Addendum 58: Regulation No. 59

Revision 12

Uniform provisions concerning the approval of replacement silencing systems

Arrangements of approval marks

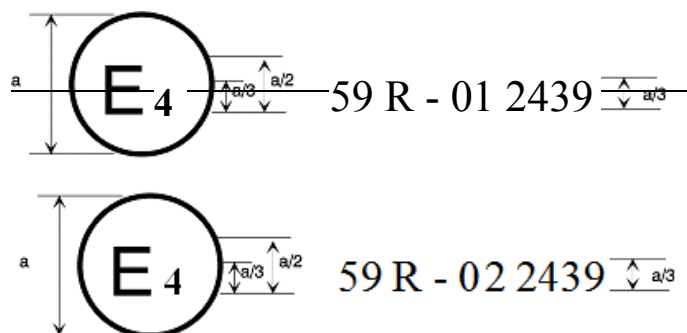
The first two digits of the approval number indicate that the approval was granted in accordance with the requirements of UN Regulation No. 59 as amended by the 042 series of amendments.
